**UKWIN'S D6 COMMENTS ON
REP5-019/20, REP5-032 & REP5-035**

Medworth EfW CHP

**Land on the Algores Way Industrial Estate to the west
of Algores Way in Wisbech, Fenland, Cambridge**

EN010110

Figure 33: Historic EfW Capacity in Development

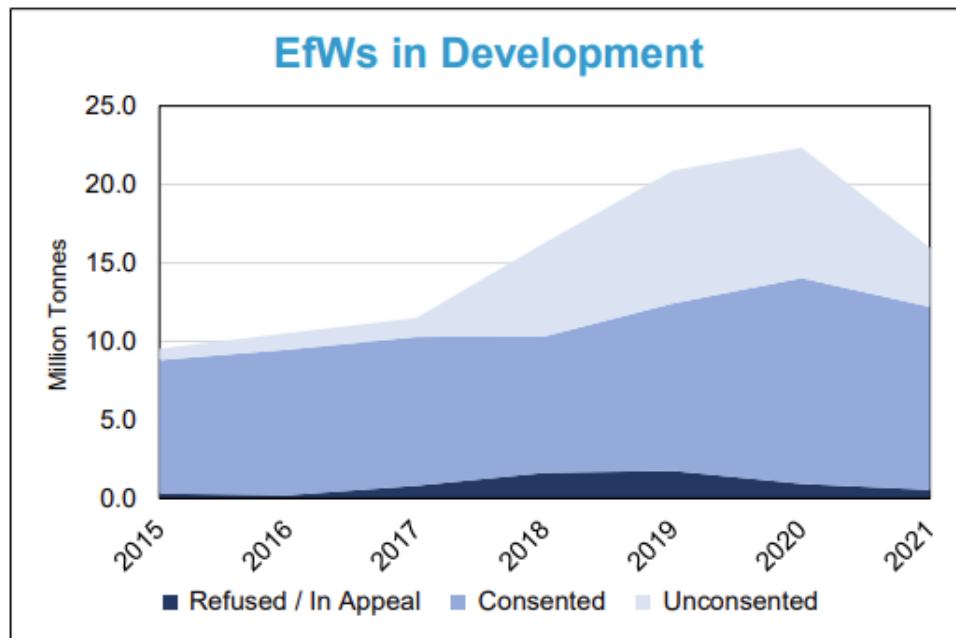
43. Tolvik’s data indicated that more than 15 million tonnes of EfW capacity across the UK (which had yet to enter construction) was considered in development at the end of 2021.

44. If it was assumed that 84% of that UK capacity was located in England, this would amount to more than 13 million tonnes of EfW capacity in development at the end of 2021.

45. This 13 million tonnes figure for 2021 contrasts with UKWIN’s 2023 figure of between 8.9 and 9.9 million tonnes.
46. When assessing which projects are or are not active there is of course an element of judgement that must be applied. It is possible that some might consider a few of the projects listed by UKWIN as not constituting active projects, but they might also consider some projects omitted by UKWIN to constitute active projects.

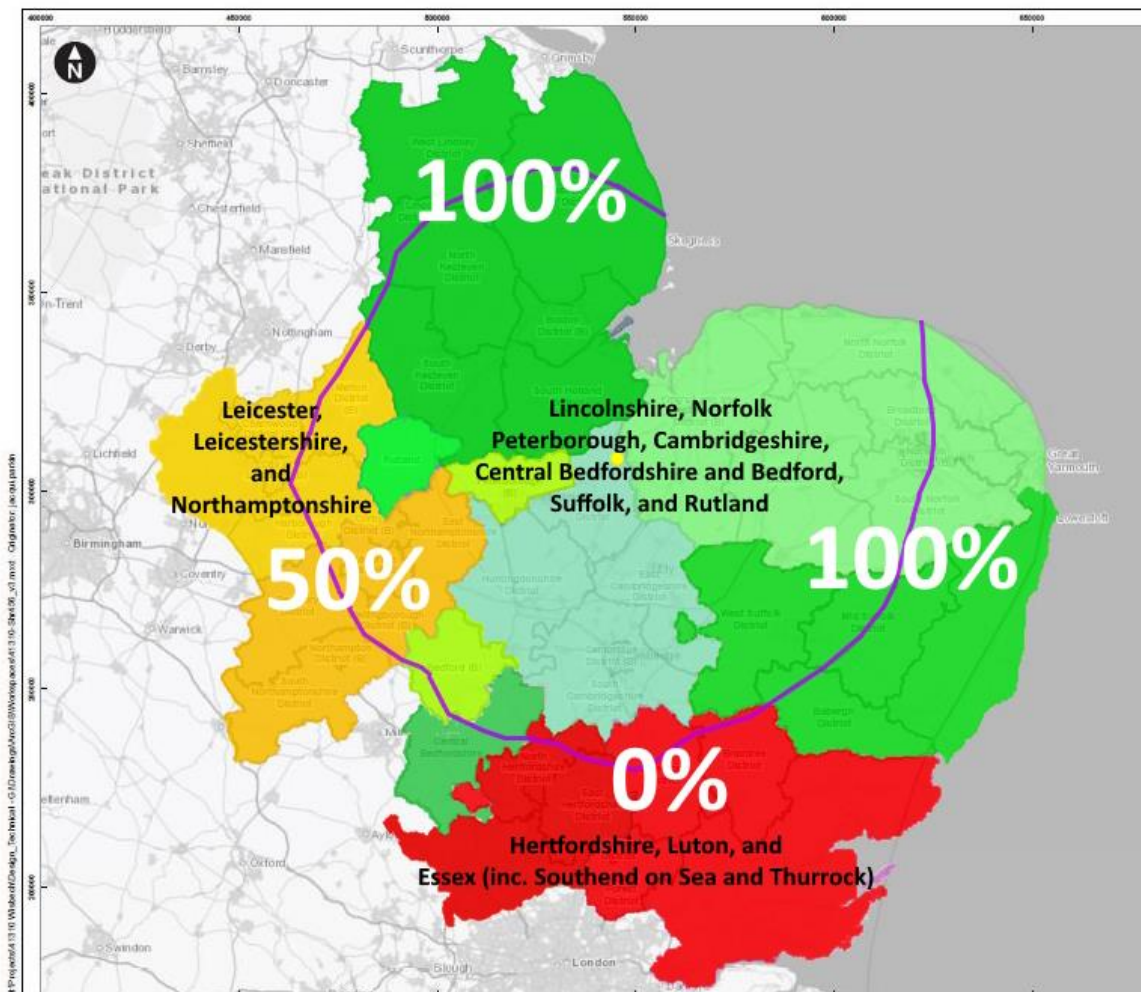
164. Whatever the merits of this approach to including significantly more land in their analysis than the c. 2-hour drive time would indicate, an approach that UKWIN and others criticise elsewhere, there is no need for UKWIN to follow the same approach in our local need analysis.

166. UKWIN has assessed REP5-020's Graphic 2 ('Medworth Location Plan for 2 Hour Travel Time of Heavy Goods Vehicles (HGV)') and it remains clear that a large proportion of the Applicant's study area goes beyond the 2-Hour Travel Time for HGVs.
